**RE: Peer Review of Dobroyd and Hawthorne Canal Flood Studies: Summation**

**RE: Peer Review of Dobroyd and Hawthorne Canal Flood Studies**

**Re: Response to Letter "Peer Review of Dobroyd and Hawthorne Canal Flood Studies"  
dated 25 May 2016**

J:\Jobs\116043\B\_Hawthorne\ArcGIS\ArcMaps\Peer\_Review\_Response\Item\_08b.mxd

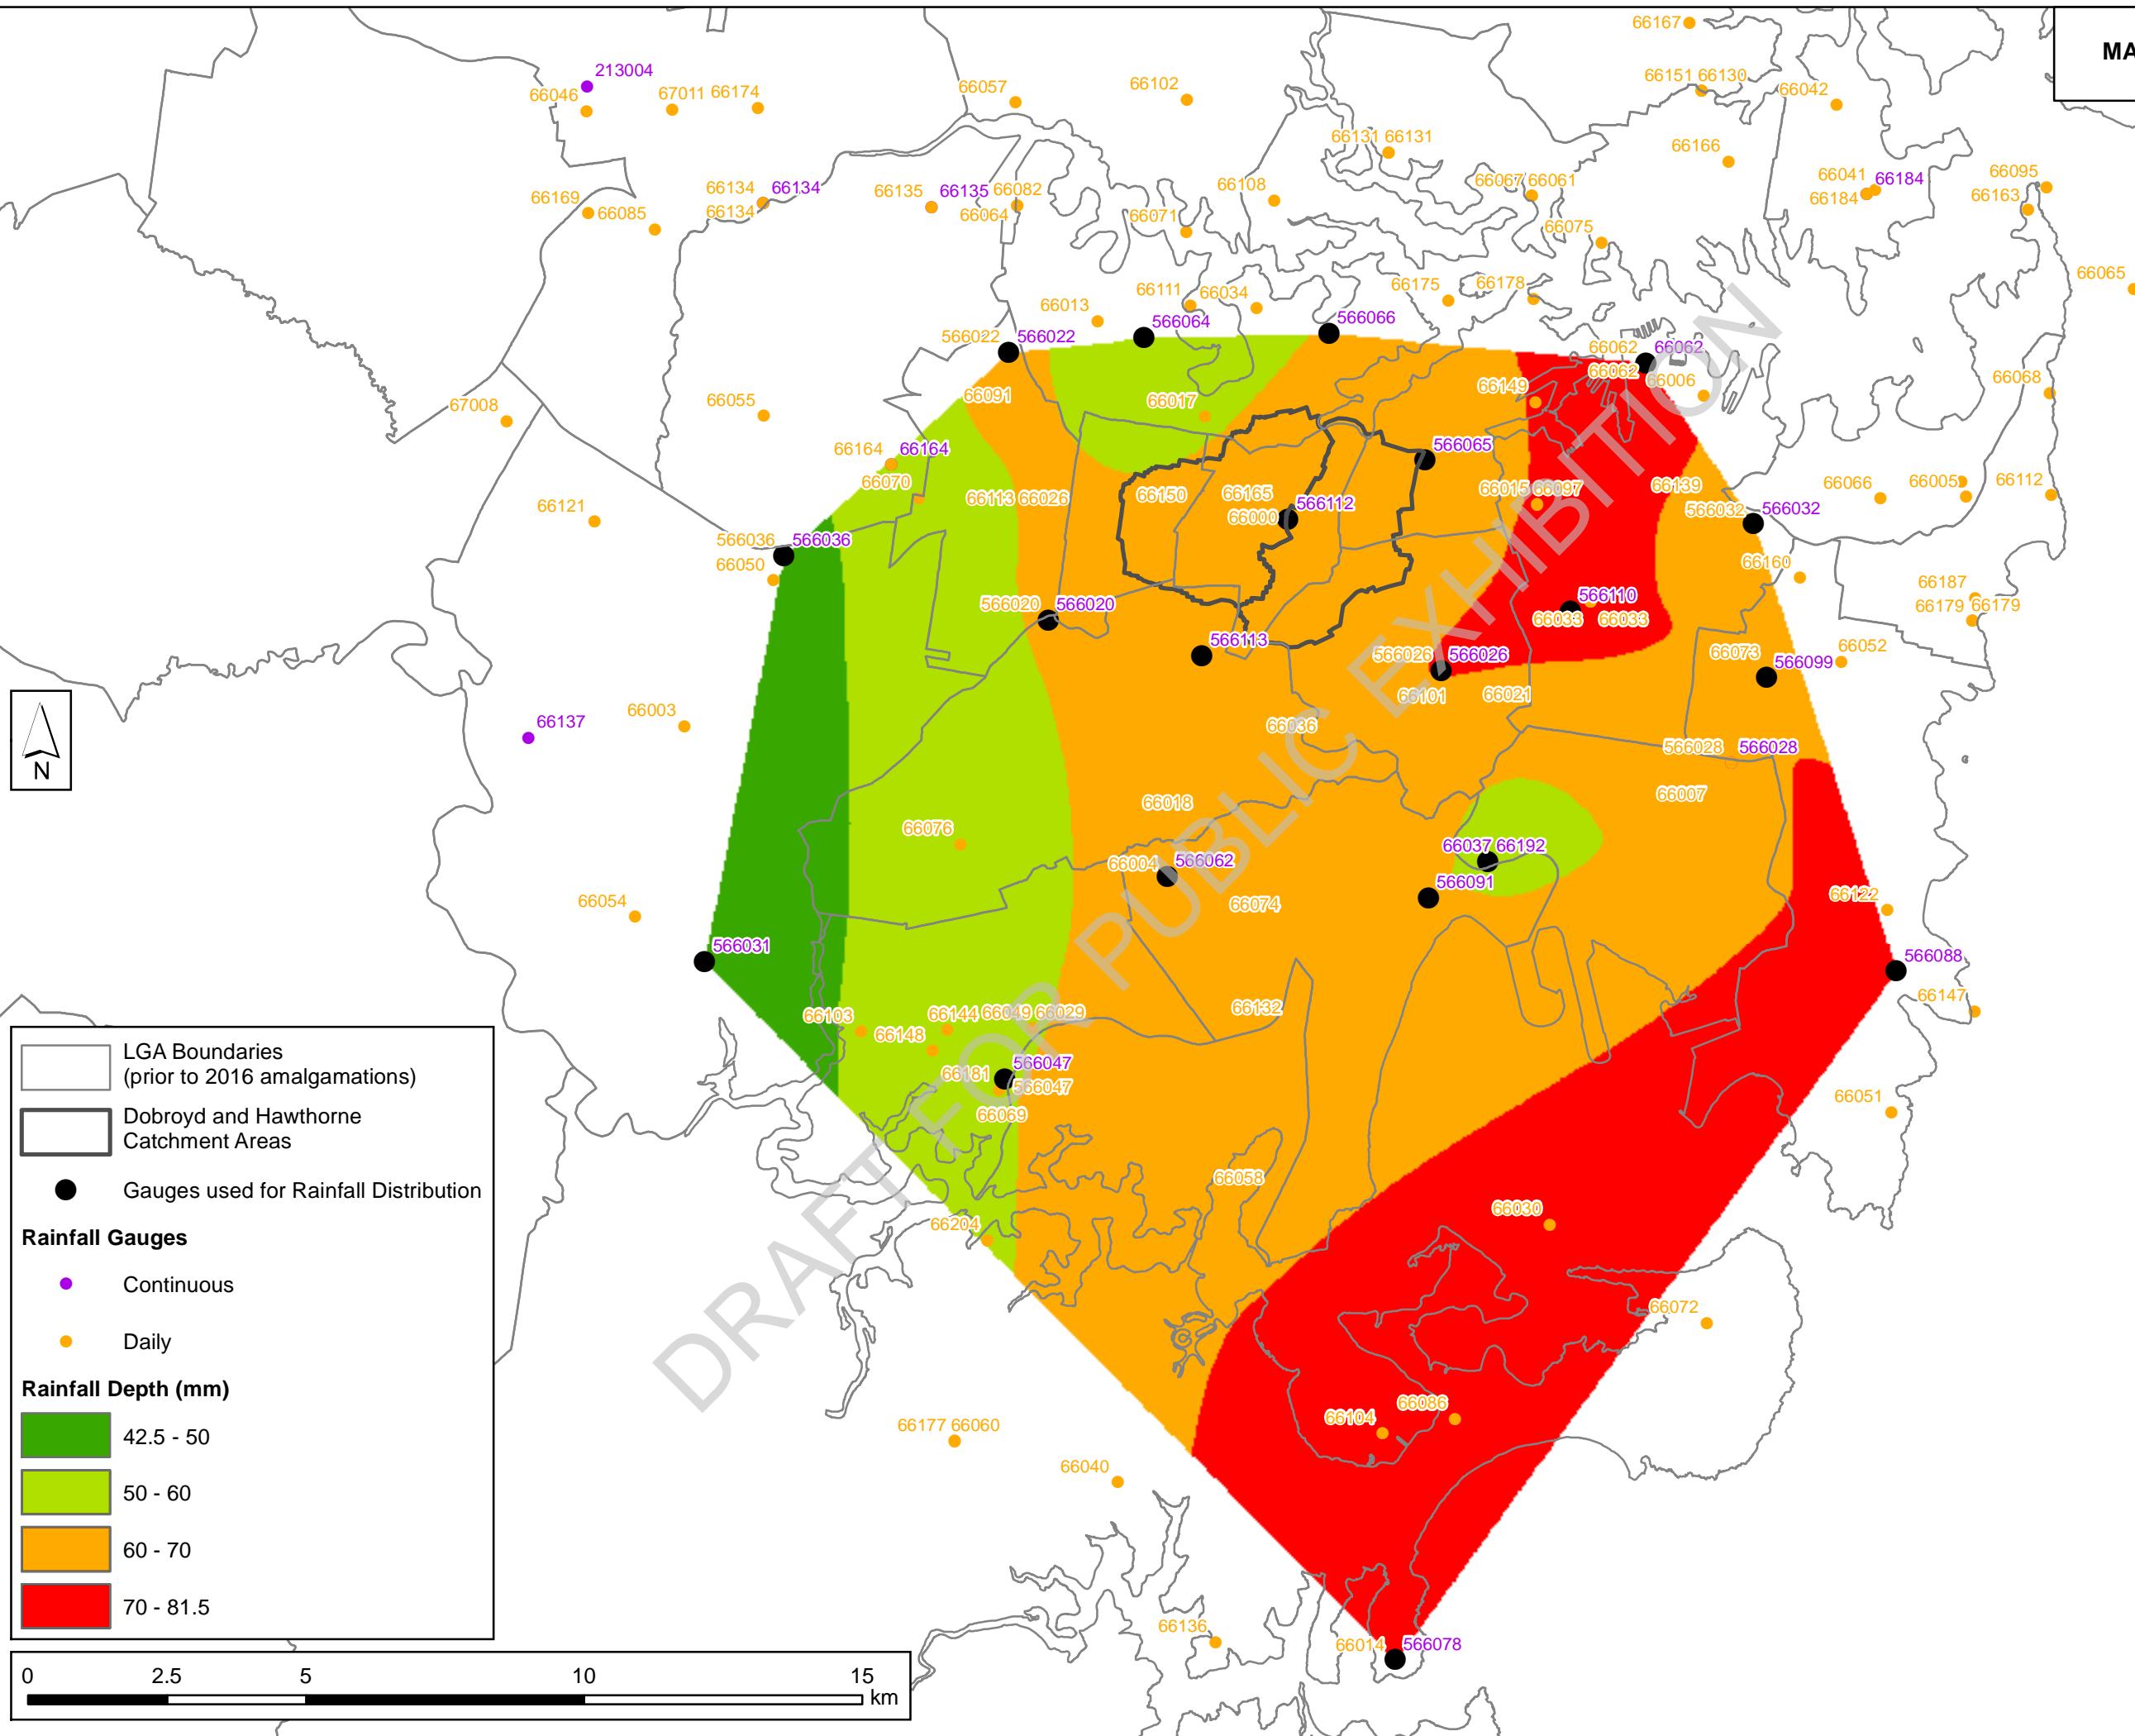
- viii. **Section 2.7 Historic Rainfall Data.** Further information on the spatial variability of rainfall would assist in the interpretation of the model calibration outcomes. Suggest that a graphical representation of rainfall e.g. rainfall isohyets for historical events in the local area, and perhaps also in the wider Sydney area compared to design rainfalls would help put the model calibration in better context;

The spatial distribution of the rainfall depths and IFD ranges is shown on “Item 8A” and “Item 8B” for the February 1993 6 hour storm burst and “Item 8C” and “Item 8D” for the March 2012 6 hour storm burst.
